Access Compliance Report

Public Rights-of-Way

Intersection ID: 28156	Main Street: ARBOR GROVE LN	Cross Street: OLIVIA LN	Location: NW
ADA ID: E6DE6EB2C1A6	Ramp Type: PerpDiag	Initial Pass/Fail: Fail	Overall Compliance: No
		Severity Score: 60

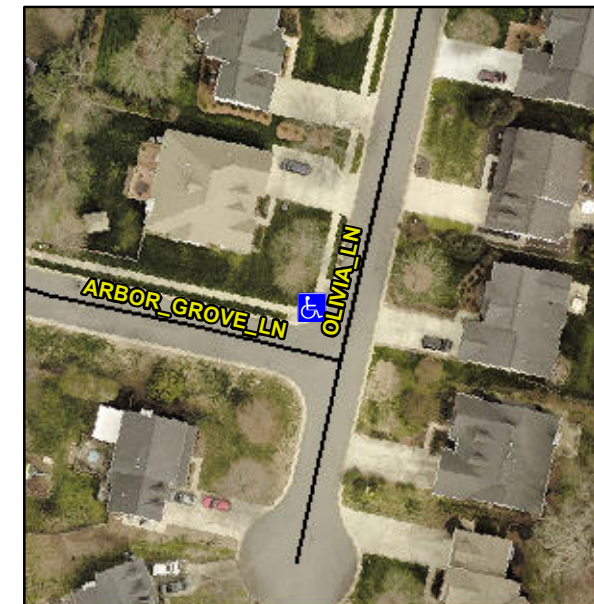
Not Found, R304.5.1, R304.2.2, R304.5.3

Compliance	Description	Data	Compliance	Description	Data
N/A	Ramp Length (in)	95.5	No	Ramp Slope (%)	8.4
No	Ramp Width (in)	25.0	No	Ramp XSlope (%)	6.1
N/A	Flare Type LT	N/A	N/A	Flare Type RT	N/A
N/A	Flare Slope LT (%)	N/A	N/A	Flare Slope RT (%)	N/A
N/A	Flare Traversable LT?	N/A	N/A	Flare Traversable RT?	N/A
N/A	Landing Length (in)	N/A	N/A	DWS Provided?	N/A
N/A	Landing Width (in)	N/A	N/A	DWS Contrast?	N/A
N/A	Landing Slope (%)	N/A	N/A	DWS Length (in)	N/A
N/A	Landing X Slope (%)	N/A	N/A	DWS Full Width?	N/A
N/A	Landing Curb? (Y/N)	N/A	N/A	DWS Offset (in)	N/A
N/A	Shared Landing?	N/A			
N/A	Gutter Ponding?	N/A	N/A	Gutter Slope (%)	N/A
N/A	Gutter Lip Ht (in)	N/A	N/A	Gutter X Slope (%)	N/A
N/A	Painted X Walk1?	No	N/A	Painted X Walk2?	No
	X Walk 1 Direction	To SW		X Walk 2 Direction	To SE
N/A	X Walk 1 Width (in)	N/A	N/A	X Walk 2 Width (in)	N/A
	X Walk 1 Slope (%)	3.6		X Walk 2 Slope (%)	2.9
	X Walk 1 X Slope (%)	4.0		X Walk 2 X Slope (%)	3.2

Remove & Replace Curb Ramp With Two New Directional Ramps or Equivalent.
